#### **PLN200192 and DA210122/SCHWARTZ MAL**

**SCHWARTZ MAL (PLN200192 and DA210122)**

**RESOLUTION NO. 21 - 264**

**ARCHITECTURAL  
 SITE PLAN**

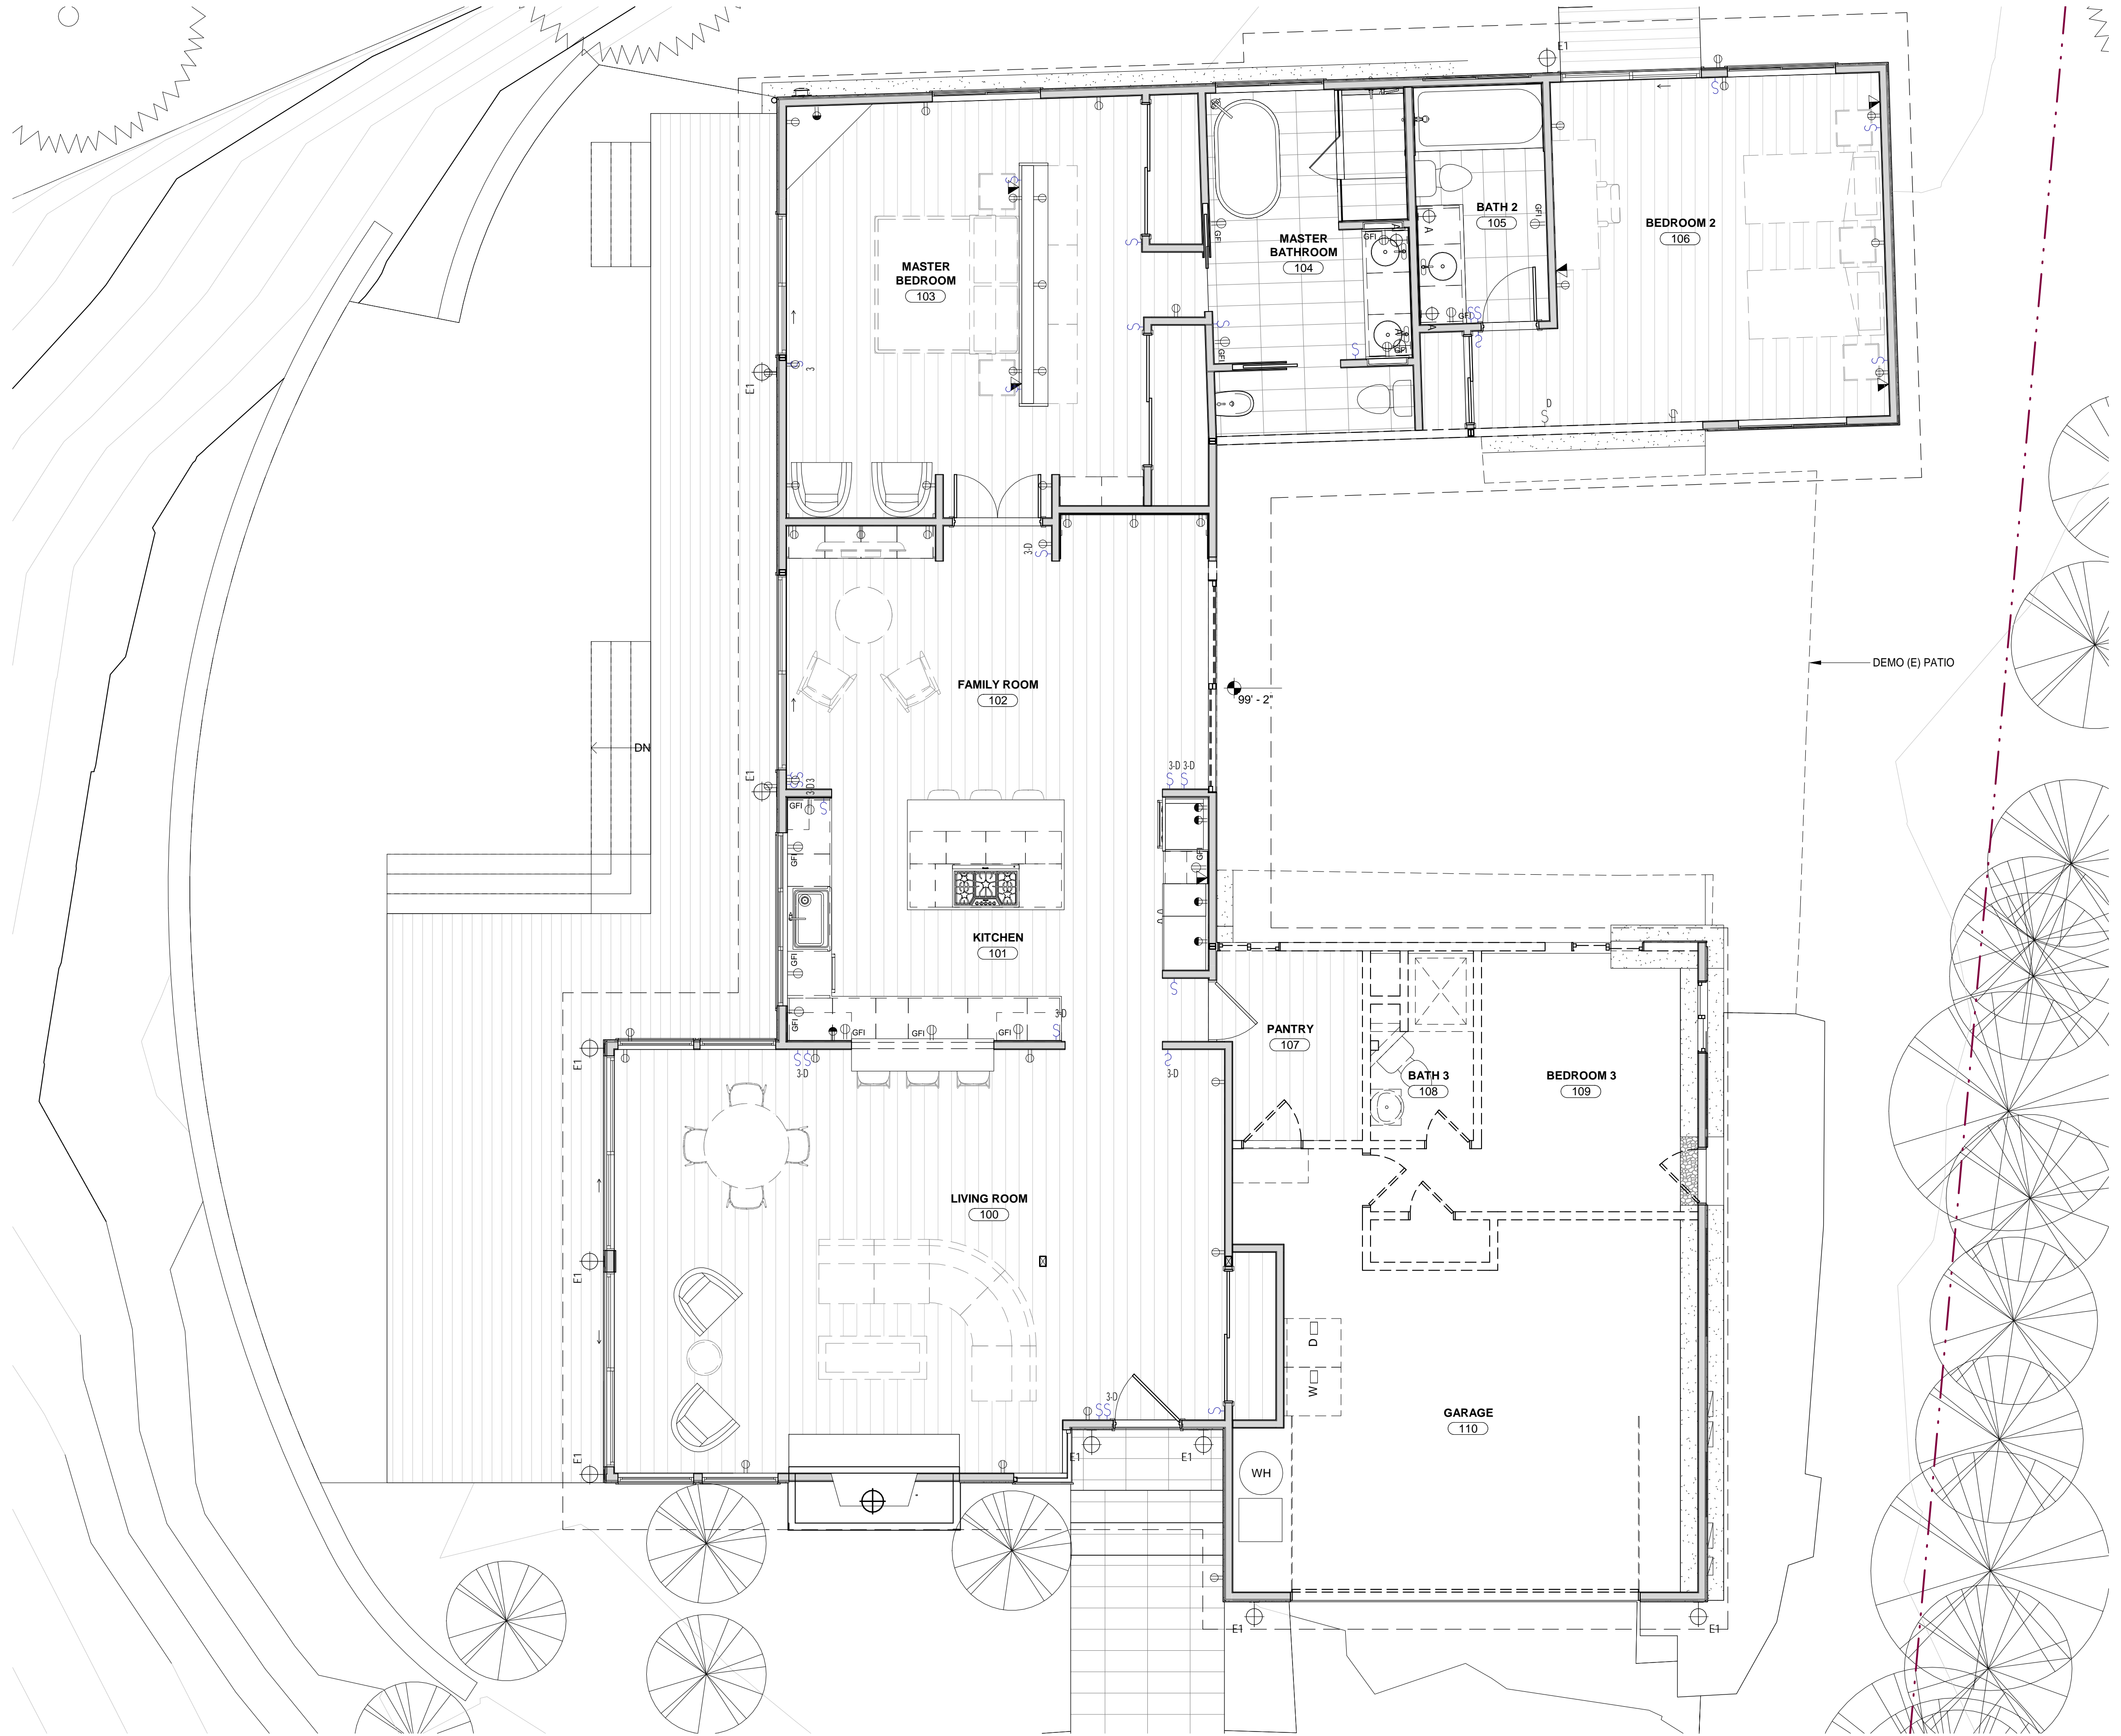
- The minimum front setback shall be 30 feet. As shown on sheet A1.0 of the proposed project plans, the proposed studio addition is outside of this setback area. The detached 2-car carport encroaches into this setback. However, under section 21.62.040(N). encroachment into this setback may be permitted for detached carports in cases where, “the elevation of the front half of the lot at a point 50 feet from the centerline of the traveled roadway is seven feet above or below the grade of said centerline...” Here, the elevation at a point at the centerline of Outlook Drive is 85 feet and 6 inches, while the elevation 50’ from centerline drive extending into the Schwartz property is approximately 95 feet. This is greater than 7 feet higher than the centerline of Outlook Drive, and therefore this setback exception is allowable.

- The minimum side setback shall be 10% of the lot width. As the width of the property is 123 feet and 10 ½ inches, the allowable side setback is 12 feet and 4 ½ inches. As shown on the site plan A1.0, the proposed 531 square foot studio addition is within this allowable setback.

- o The 63 square foot deck for this addition does encroach into the required setback.
  - o The 4 to 6 foot tall fence also runs along the plan east property line. However, pursuant to the definition of structures in Title 21 section 21.06.1220, a fence under six feet in height is not a “structure” and is therefore not subject to the setback requirement.

- The minimum rear yard setback shall be 20 feet. As shown on sheet A1.0 of the proposed project plans, the scope of work for the project is outside of this setback area.

SHEET REF:	A3.8
REVISED DATE:	
ISSUED DATE:

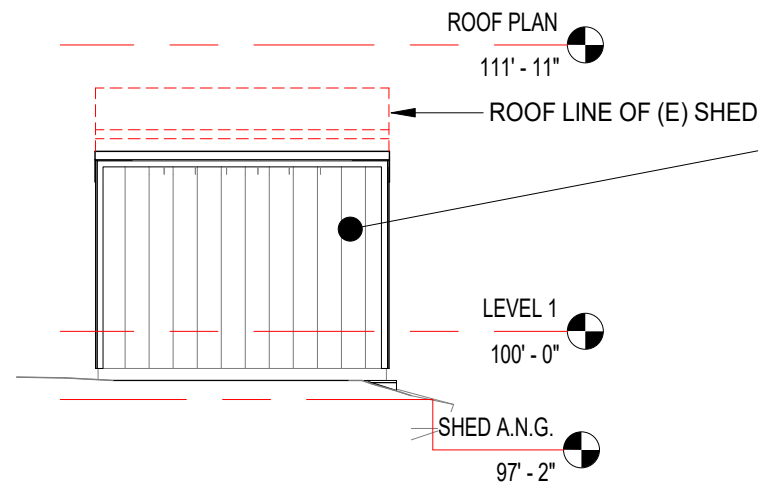
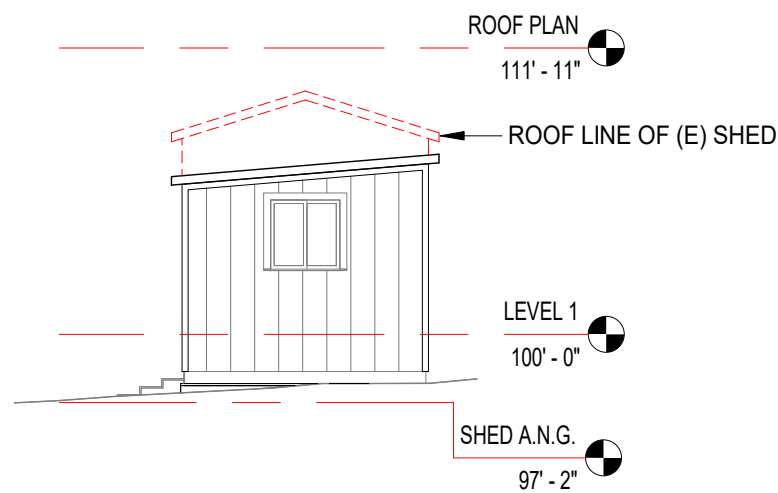
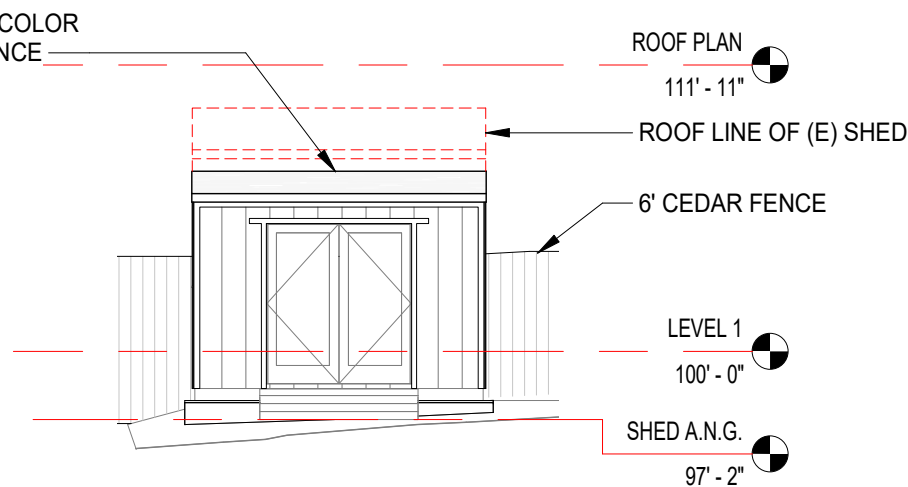
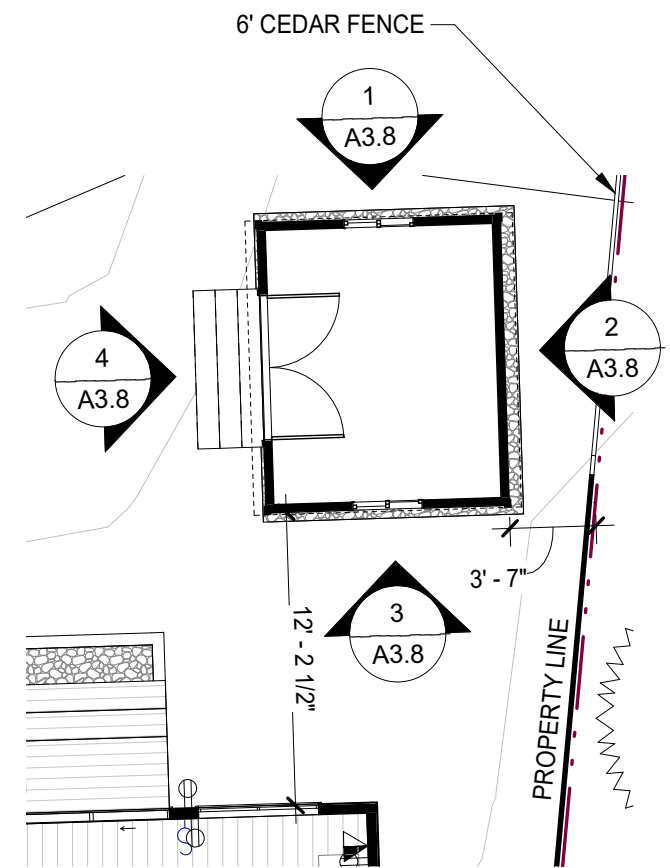
- c) Shed. In correspondence received from the public, it was indicated that the height, structure, and finishes of an existing shed on the property were different from and in violation of their original planning approval, DA190154. In researching this approval, county staff reviewed the elevations and finish materials attached to the approval resolution for DA190154 and determined that the finishes and skylights were installed as per the original approval. Staff did not independently verify whether the height of the shed was higher than its originally approved height of eight feet prior to the May 13, 2021 Zoning Administrator hearing. At the hearing, Applicant’s representatives indicated that the shed was twelve feet high, four feet higher than allowed under the original approval. While the underlying zoning permits unhabitable accessory structures up to fifteen feet, Applicant’s non-compliance with the terms and conditions of the original permit being installed higher than originally approved violated the conditions of the original permit DA190154, and as such is a violation of the provisions of the zoning ordinance. To address this, a project specific condition, “PDSP002”, was applied by the Zoning Administrator which would require the Applicant to either:

The change in shed height was neither previously permitted nor disclosed at the May 13, 2021 Zoning Administrator hearing. Therefore, the County finds that the contention regarding the height of the shed is with merit. To address this, approval to modify the chimney to approximately 9 feet in height is included as design approval request DA210122. Additionally, the addition or removal of electrical to a shed does not change the land use as defined in the zoning ordinance.

The issue regarding the height of the shed was discussed at the April 19, 2021 Carmel Valley LUAC meeting. At the meeting, Ms. Kemp attested that the shed had been enlarged to 12 feet tall, while Applicant’s representative maintained that the shed was 8 feet tall. Staff did not verify the height of the shed prior to the May 13, 2021 Zoning Administrator hearing. At the Zoning Administrator hearing, Applicant’s representatives conceded that the height of the shed was 12 feet tall, 4 feet higher than its original approval. To address this, the Zoning Administrator imposed a project specific condition “PDSP002 – SHED”, which would have required Applicant to either remove the shed or secure the necessary planning entitlements to have it legalized prior to the issuance of building permits.

- i) On July 26, 2021 the Applicants representatives submitted a revised plan set to HCD-Planning. This plan set:
  - Modified the height of the shed to be approximately 9 feet and changed its roof slope.

- Indicated a brown paint finish for the shed.
  - Removed the skylights and upper windows of the existing shed.
  - Reduced the height of the height of the Chimney to 111' – 0" and added a new termination cap for the chimney which cap will not be located on the top of the reduced chimney.

However, as discussed in Finding No. 8, addressing a zoning violation through a condition requiring application for further entitlements does not cure the zoning violation, and pursuant to MCC 21.84.120, no department may issue permits where there is a zoning violation on the property unless such permit is, in whole or in part, a cure for said violation. After the hearing, the height of the shed measured 12 feet and 11 and a ½ inches, and was slightly further from the property line and the main house than was indicated on the originally permitted plans. To address this, approval of the increase in permitted height of the shed to approximately 9 feet is included as design approval request DA210122.
